**SUBJECT:** Referral to Development Engineer for Comments

**DESCRIPTION:** Queanbeyan Civic and Cultural Precinct Including Public Admin building, basement car parking, subdivision and additional precinct works

# DEVELOPMENT ENGINEERING REFERRAL

**DA.2020.1022 – Public Administration Building Including Civic and Cultural Precinct, Basement Car Parking, Subdivision and Ancillary Infrastructure**

**Existing Utilities Plan – 257 Crawford Street, Queanbeyan**

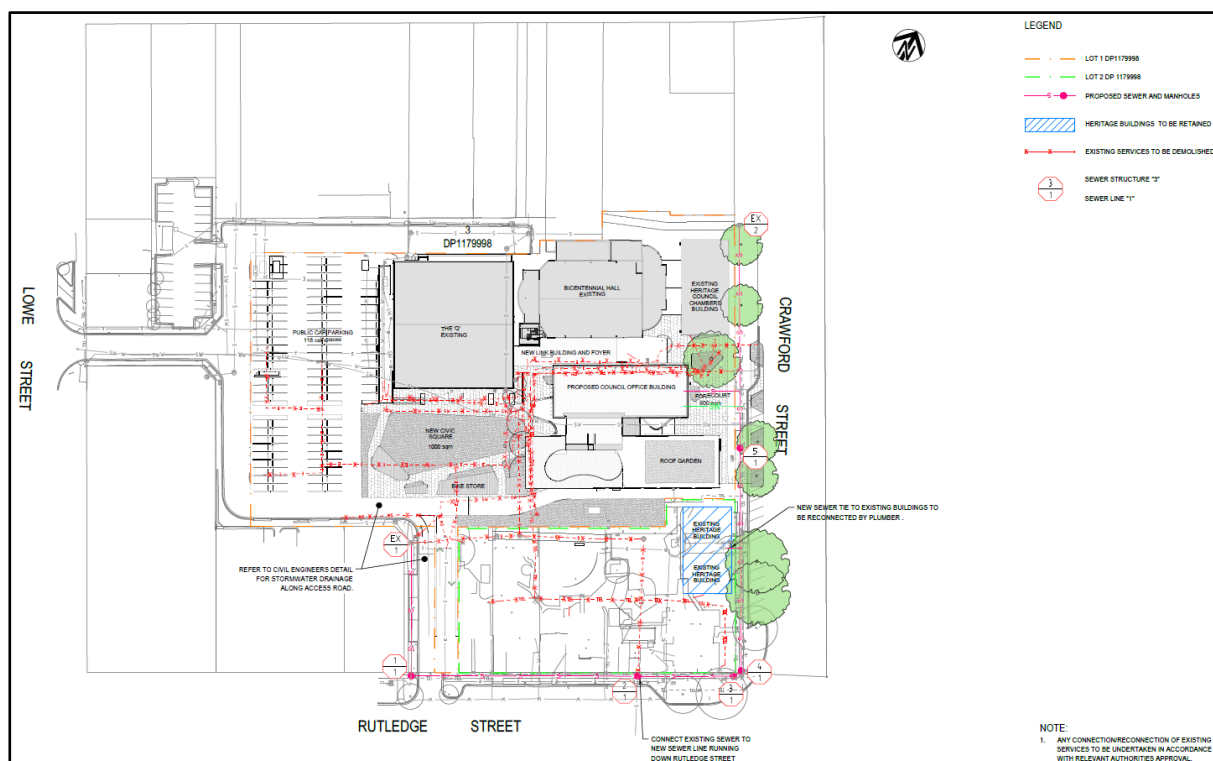
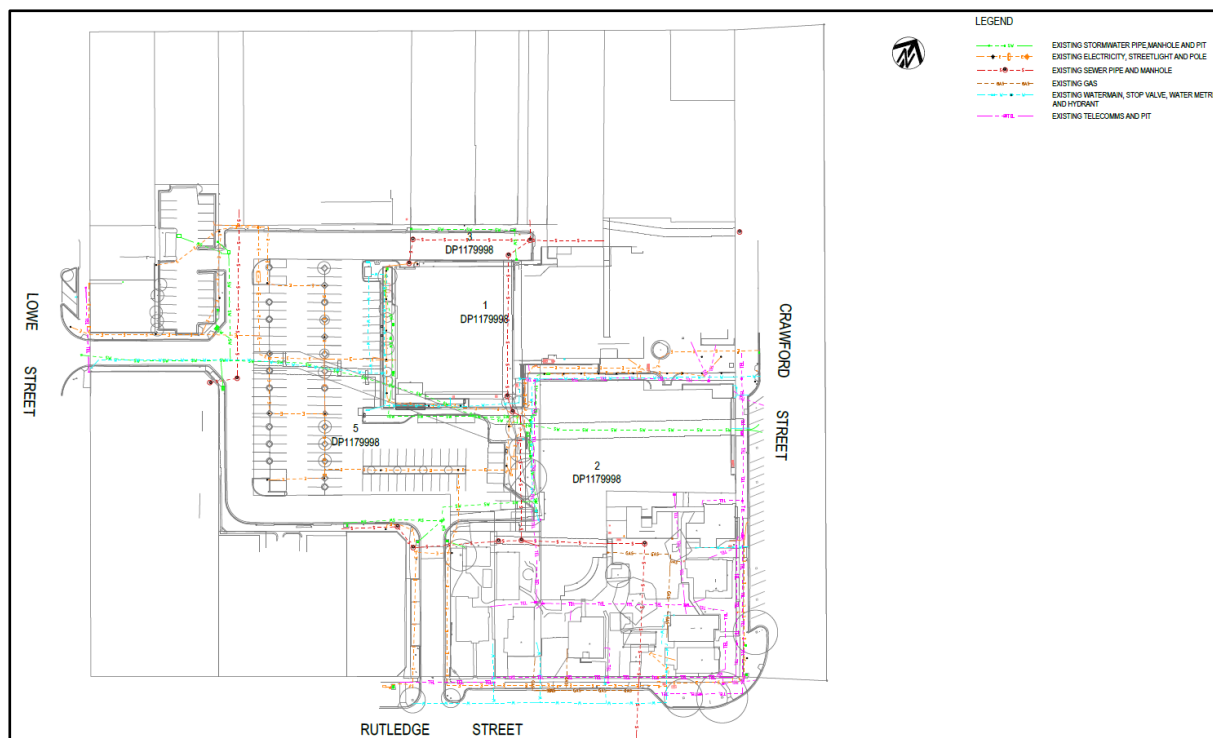
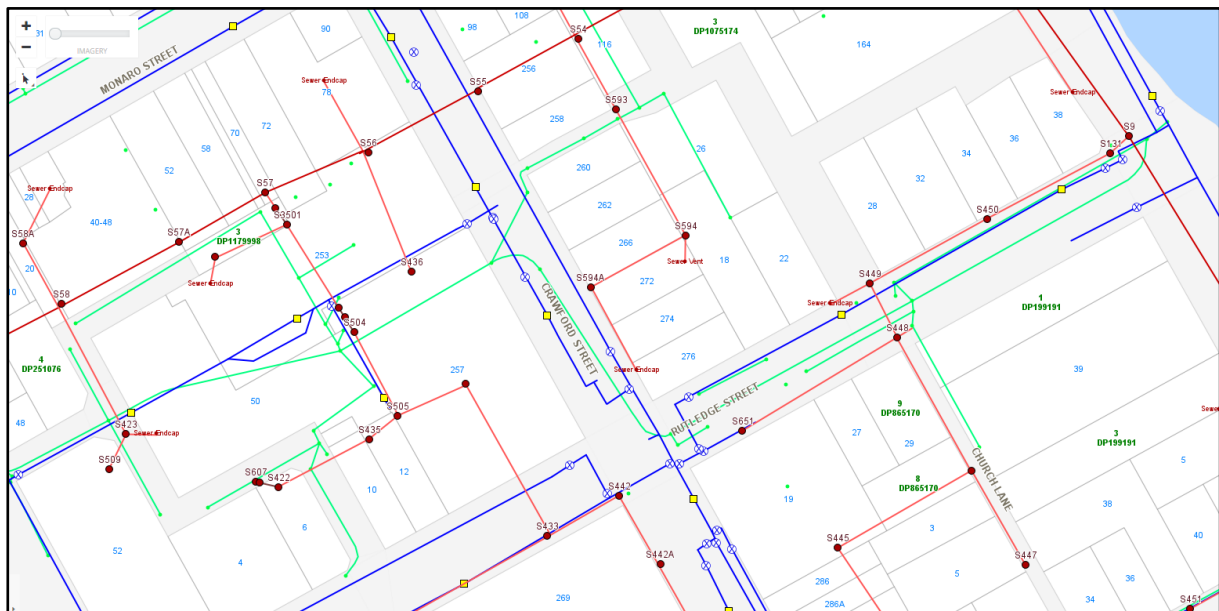
The development and subdivision site is currently serviced by multiple 150mm sewer ties, noting the following and currently existing local sewer mains encompassing the location that feed into the 225mmØ PE trunk sewer main;

- Local Main 150mmØ VC (Site – North = S58-S57A-S57-S56-S55) to be retained,
- Local Main 150mmØ VC (Site – West = S504-S505) to be decommissioned,
- Local Main 150mmØ VC (Site – South = S435-S505-S434) to be decommissioned,
- Local Main 150mmØ AC (Rutledge Street = S432-S433-S442) to be retained.

The locations can be identified by the IntraMaps Utility mapping. A number of these local mains will become redundant and decommissioned with the development as shown on the Proposed Services Plan 3002597-DA-015 dated 5 December 2019 as prepared by SMEC.

A new 150mmØ PVC sewer main is proposed to commence from a new sewer manhole located adjacent to the north corner of 6 Rutledge Street and between existing manhole S422 and S435, south along the laneway to Rutledge Street northern verge, east to Crawford Street, and north with western verge of Crawford Street reconnecting to existing sewer main with a new sewer manhole located between S56 and S55 manholes. The building footprint location will not impact on the proposed new sewer main and diversion.

The development and subdivision site is serviced by multiple storm water connections to 375mmØ drainage pipes which connect to the 2400mmØ trunk stormwater line in Crawford Street. The locations

can be identified by the IntraMaps Utility mapping. A number of the minor stormwater line will become redundant and decommissioned with the development as shown on the Proposed Services Plan 3002597-DA-015 dated 5 December 2019 as prepared by SMEC.

The proposed development of the site may increase runoff, thus a stormwater management plan demonstrating the proposed development will not exceed pre-development runoff flow for both 20% and 1% storm events is required in accordance with Council's D5 Stormwater Drainage Design specification, and water quality in accordance with Council's D7 Erosion Control and Stormwater Management Design specification and corresponding computer modelling.

**Swept Paths for B99 Vehicle for Proposed Underground Car Park**

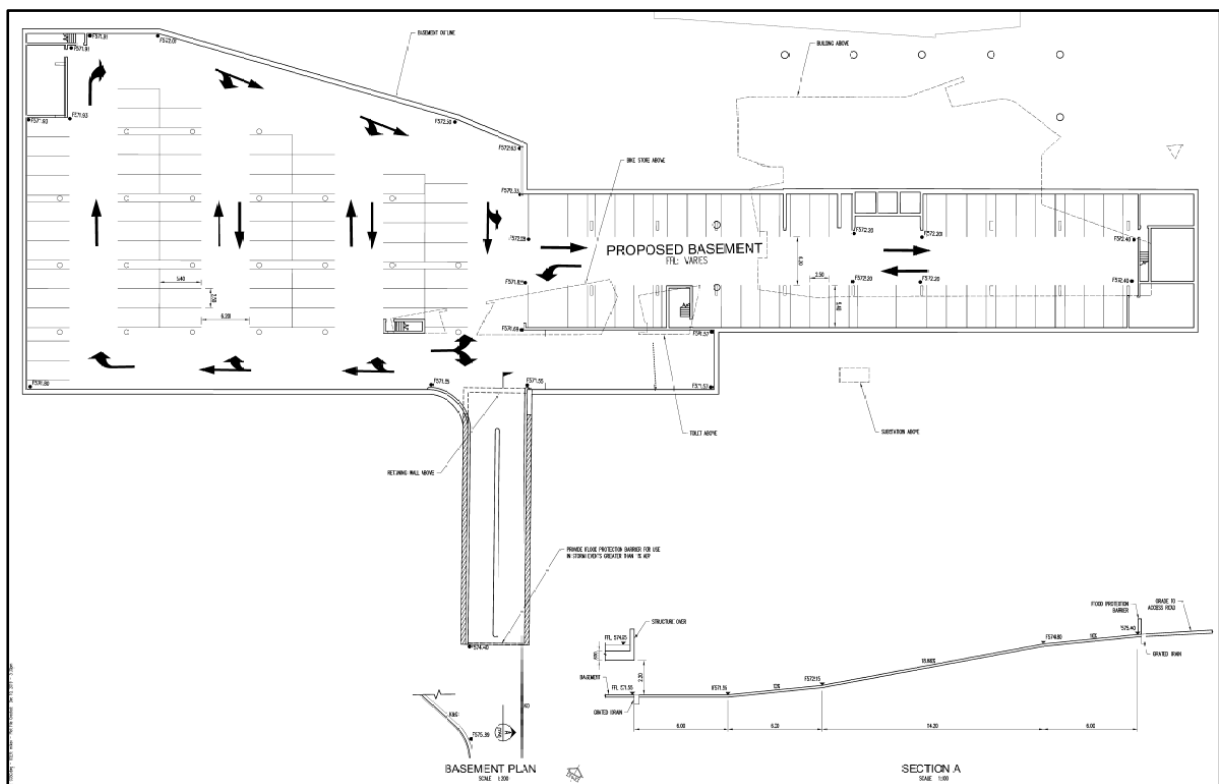
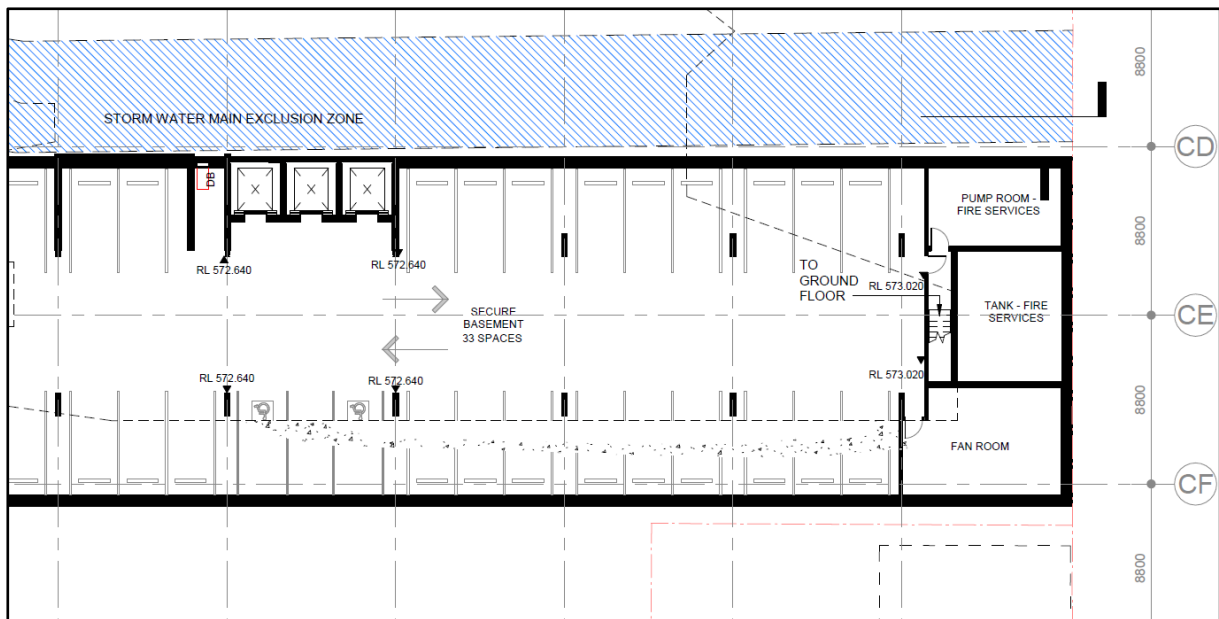
The site parking plan received demonstrates all parking space dimensions, travel direction, swept paths for a B99 vehicle.

Although there appears to be a slight discrepancy in the calculations contained in the updated Traffic and Parking Assessment dated 26 June 2020 as prepared by TTW, the total number of parking spaces exceed the requirements under the *Queanbeyan DCP 2012 Section 2.2.6* by an additional 14 car spaces being provided. There are two (2) disabled car parking spaces provided in the underground car park located opposite to the three lifts.

### Swept Paths for HRV 12.5m Delivery Vehicle from Crawford Street

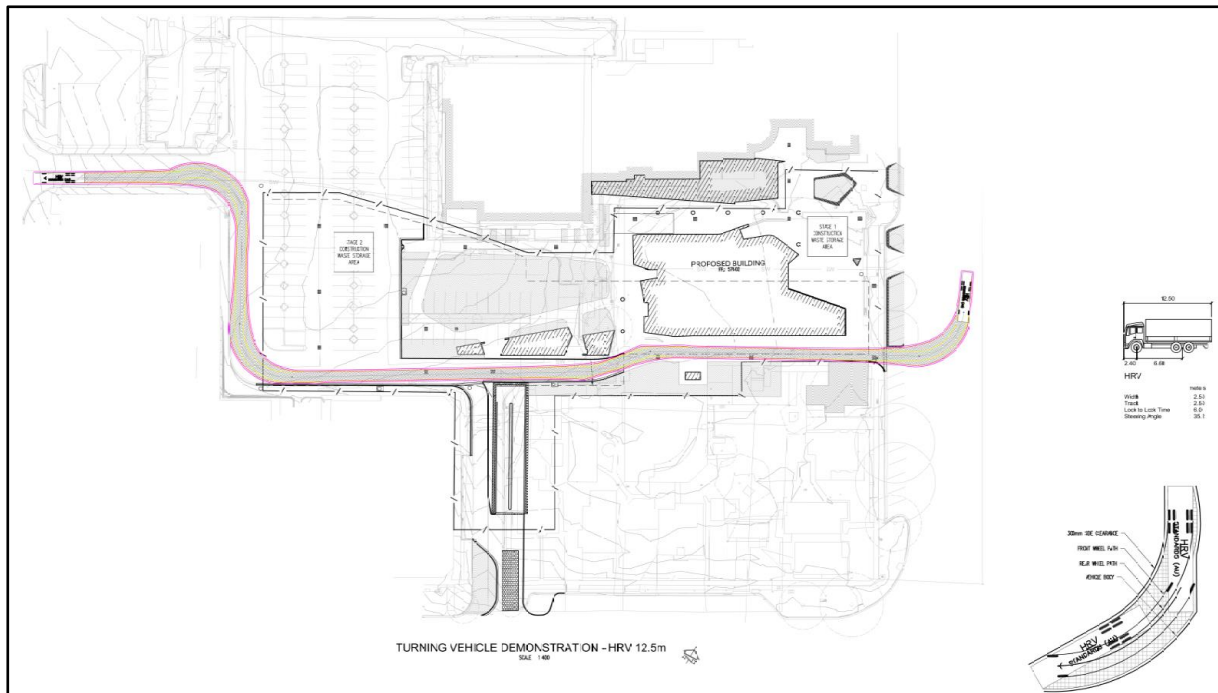
The internal access has been designed based on passenger vehicle manoeuvrability and car park functionality for B99 vehicle. The delivery access off Crawford Street has been designed based on heavy ridged 12.5m vehicle manoeuvrability.

**1% AEP Flood Hazard Zones – 257 Crawford Street, Queanbeyan**

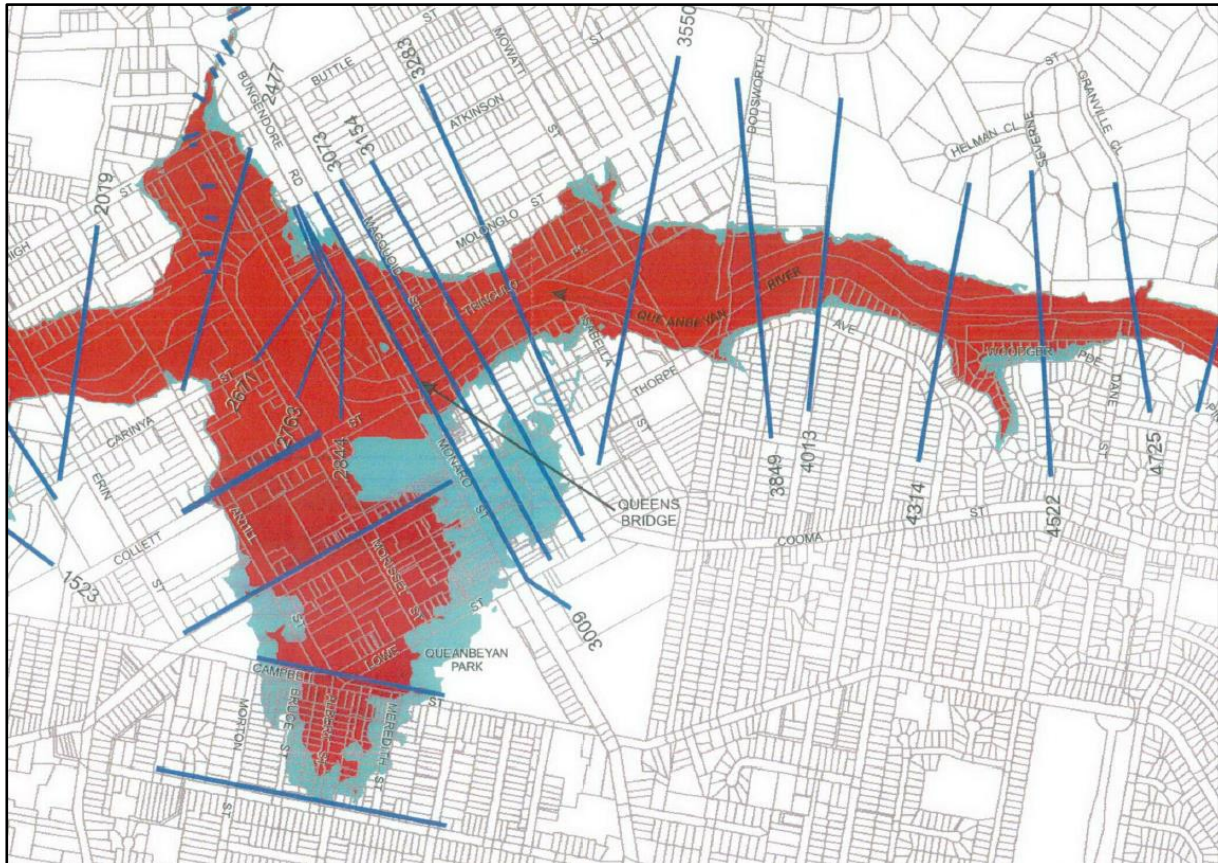
The development and subdivision is above the Flood Planning Level, but within the Flood Planning Area. The 1% AEP flood level at development site is RL575.52m AHD (shown in red below). The submitted Statement of Environmental Effects report dated 10 February 2020 as prepared by SMEC states the building has no impact on flood levels and complies with the flood planning level (including 500mm freeboard and shown in blue below) with a ground floor level of RL576.02m AHD.

The submitted Statement of Environmental Effects report dated 10 February 2020 as prepared by SMEC states the entry to the underground car park is above the 1% AEP (including 500mm freeboard) and proposes a battery backup flood gate to restrict flood water into the underground car park. The proposed access surface level at the grated drain and flood gate is RL574.40m AHD noting the surface level at Rutledge Street is RL576.13m AHD.

The underground car park hydraulics system has a capacity of 17 L/s pump out to above the 1% AEP flood level. However, I am unable to locate stormwater pump out details on the underground car park design, but noted the grated drain. There is a pump room for fire services.

**Former QCC Administration Office Building – Indicative Area of Top Floor**

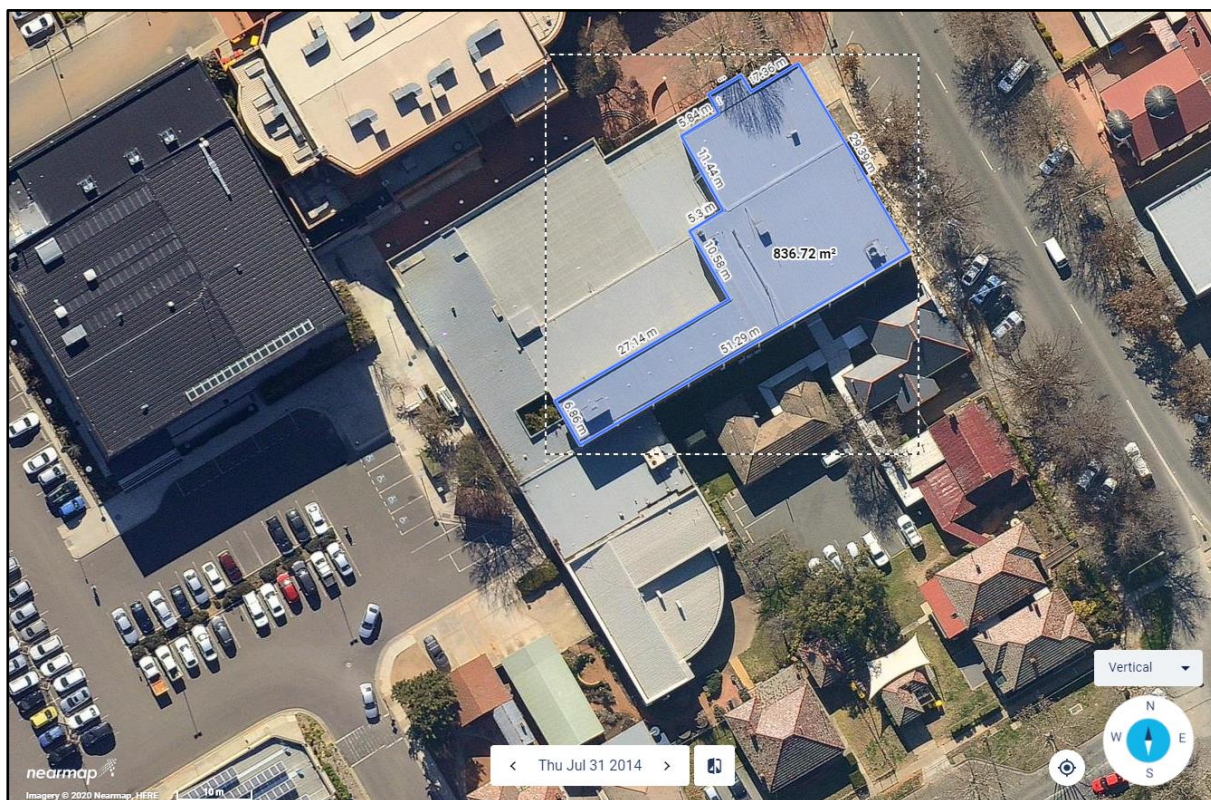
Section 64 contributions would have been levied previously for the former QCC administration building with credit calculations based on the indicative ground floor area and first floor area of former QCC administration building 2,640m<sup>2</sup> and 837m<sup>2</sup> respectively for a total of 3,477m<sup>2</sup>. Based on these figures and applying the commercial property credit rate of 15 ET/Ha for both water and sewer, a credit of 5.22 E.T. was determined.
